Third Addendum to the Los Angeles Memorial Coliseum Renovation Project EIR

Existing and Proposed Video Board Graphics

**Los Angeles Memorial Coliseum
Potential Impacts of Approved vs. Modified
Project on Character-Defining Features
Review of Additional Modifications
Third Addendum, November 23, 2016**

1) View within Coliseum bowl

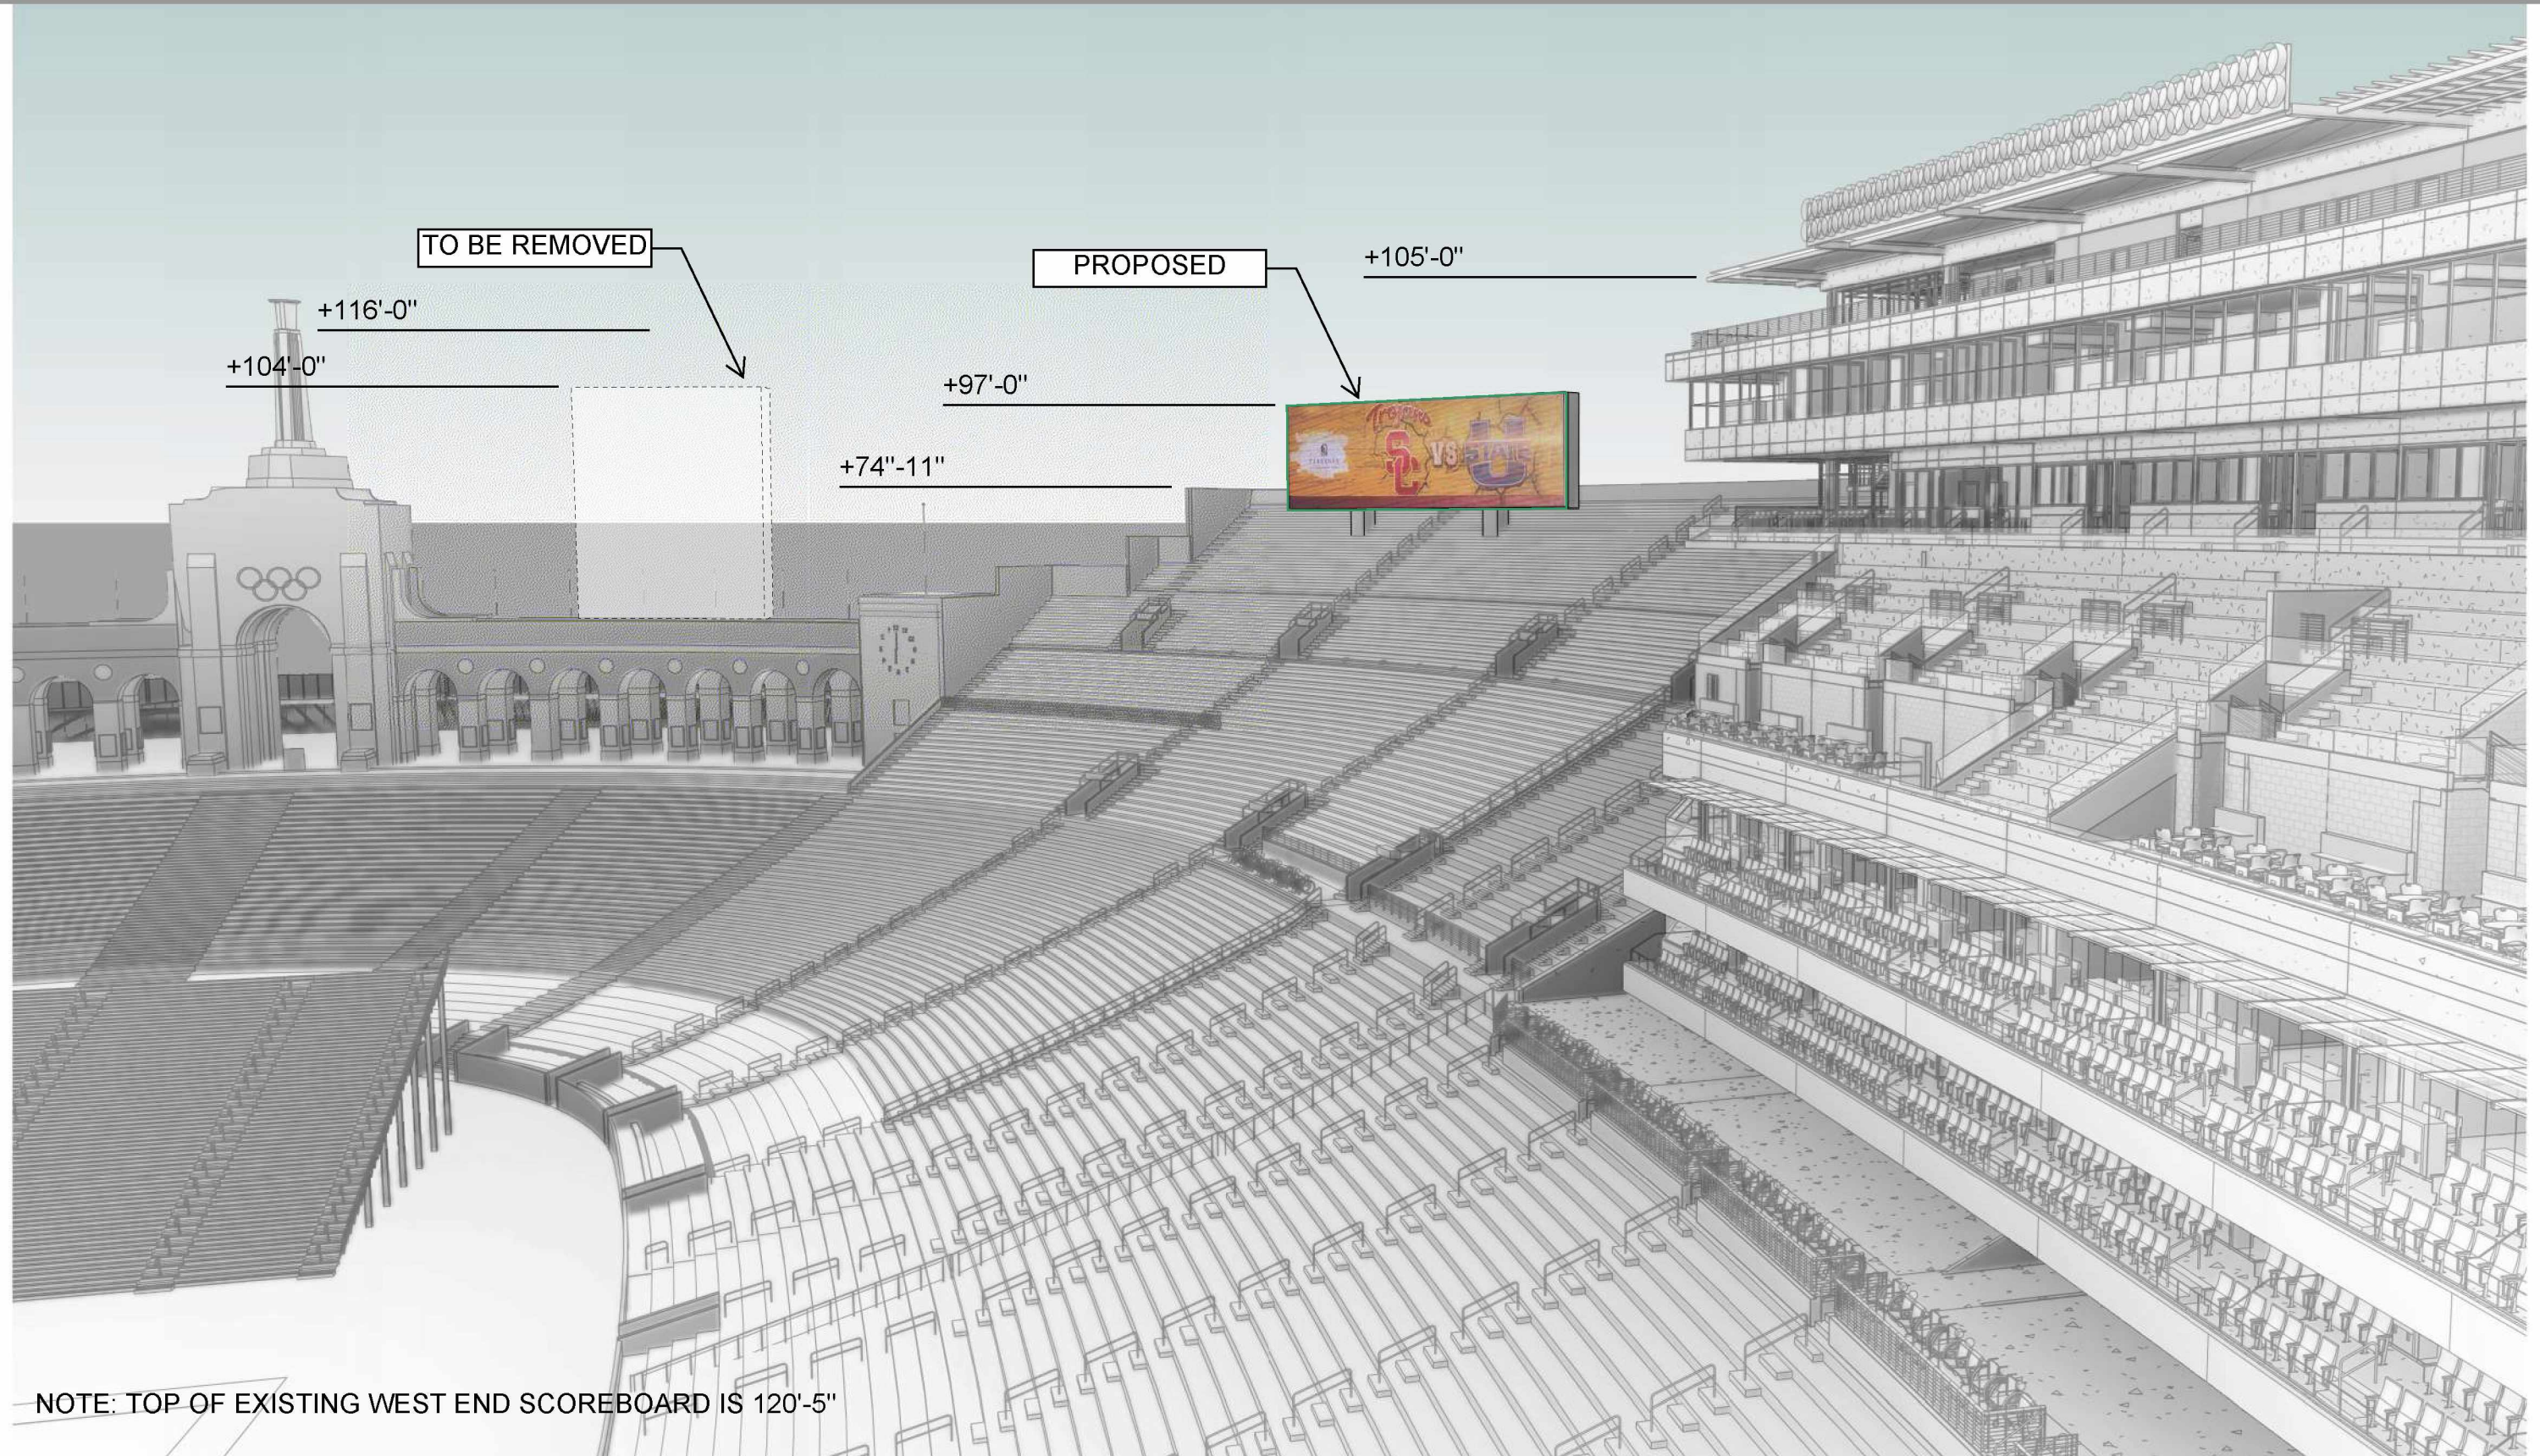
NOTE: TOP OF EXISTING WEST END SCOREBOARD IS 120'-5"

PROPOSED SCOREBOARD - HIGHWAY 110 -VIEW

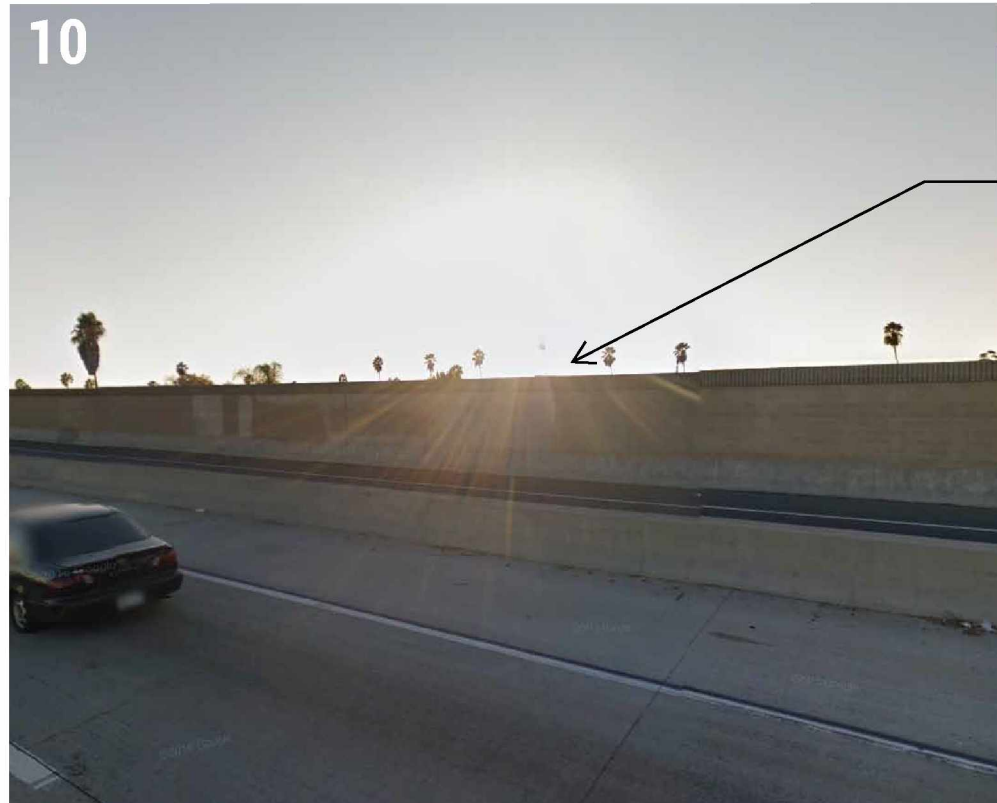
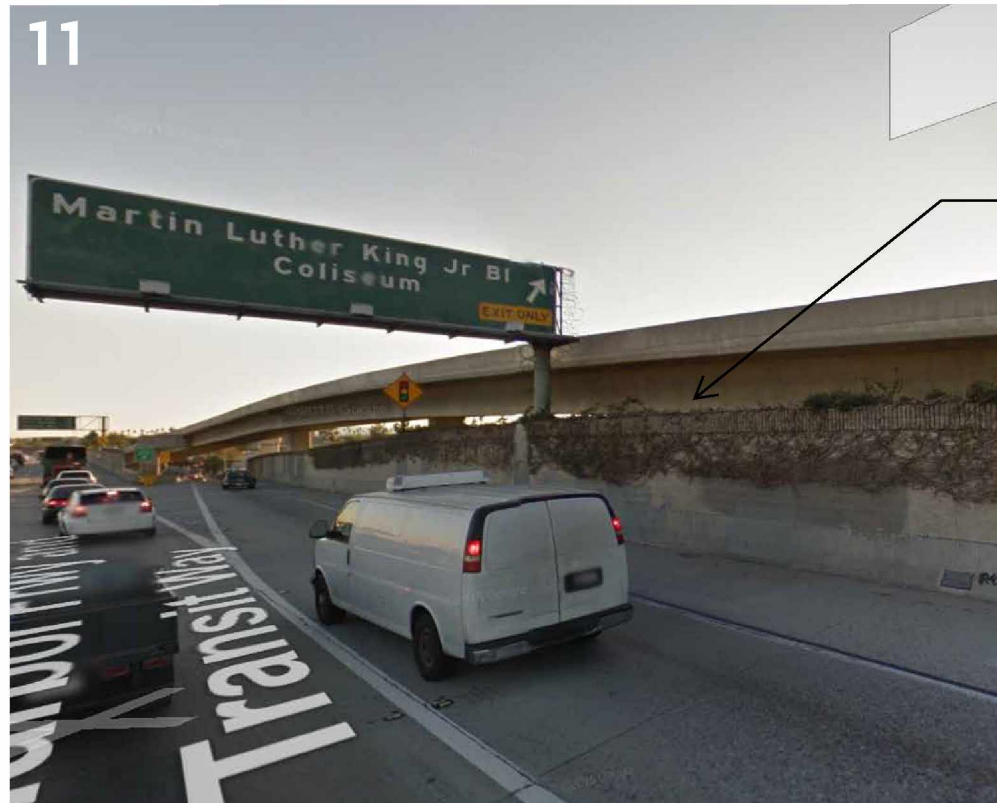
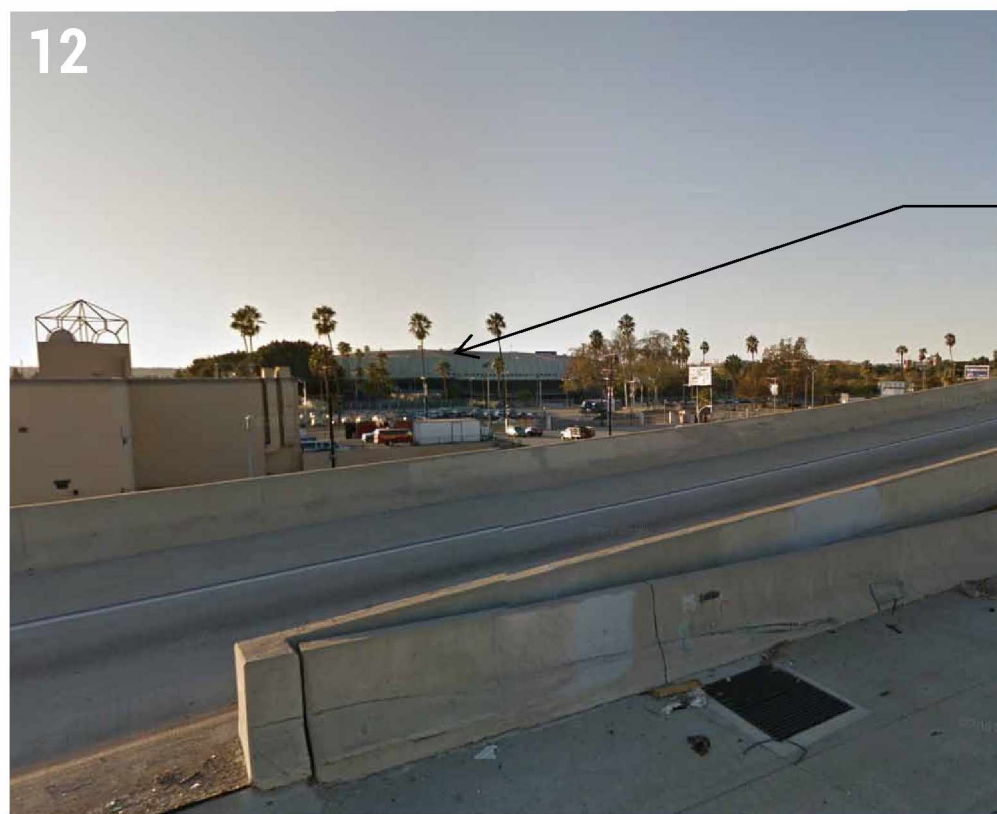
Views along the highway towards the Coliseum are mostly obstructed except for the hwy on-ramp from Exposition Blvd.
